The
University of Oklahoma at Norman

Reference: Docket 50-112

Subject: License Amendment Request

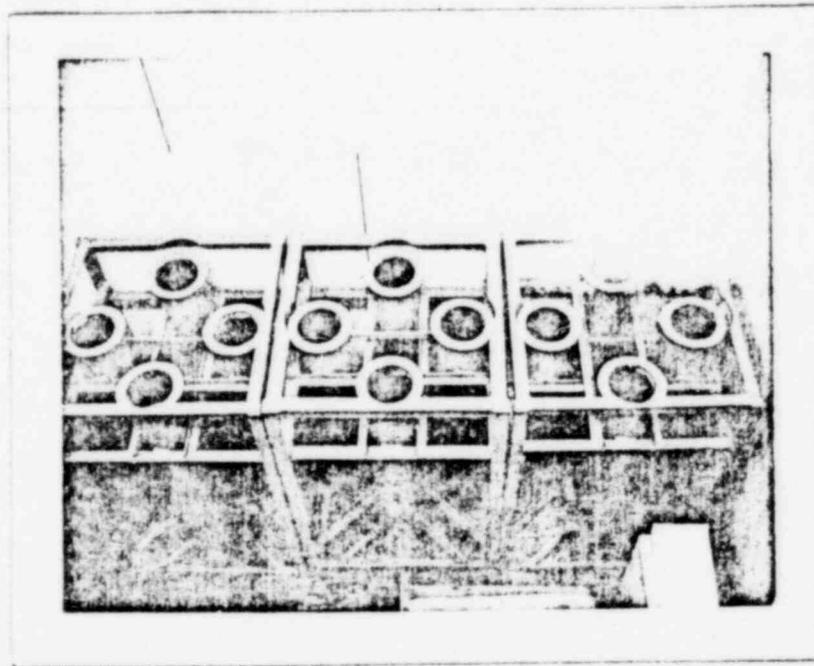
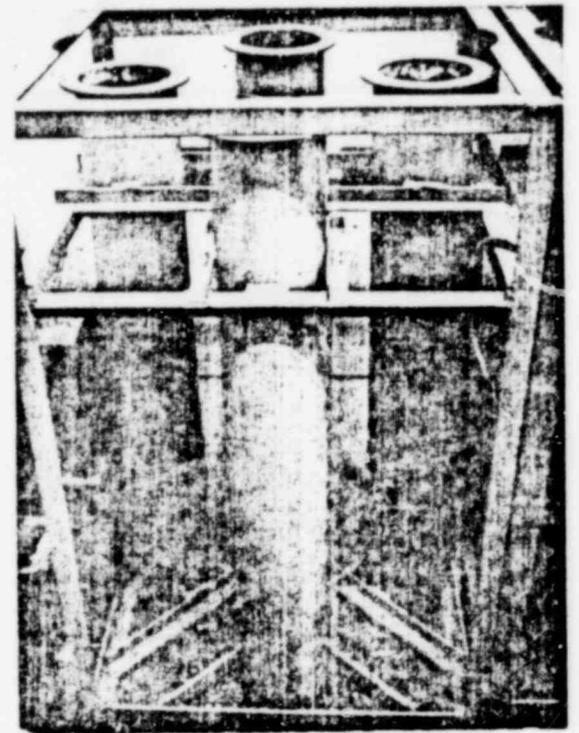
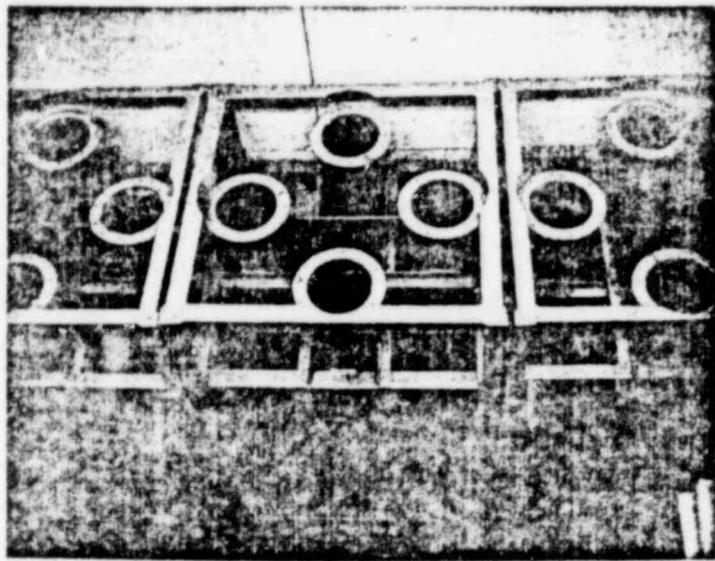
Presuming NRC concurrence with this request we are making available additional fuel element storage racks to be placed and kept in the isotope and storage pit located immediately adjacent to the reactor's biological shield. These non-critical geometry, steel, fuel-element storage pipes are mounted in a welded-steel framework. The pipes are placed ~15 inches between centers. Once the fuel element is in place a flat top-plate is bolted on and locked to prevent removal of the element (see attached photos).
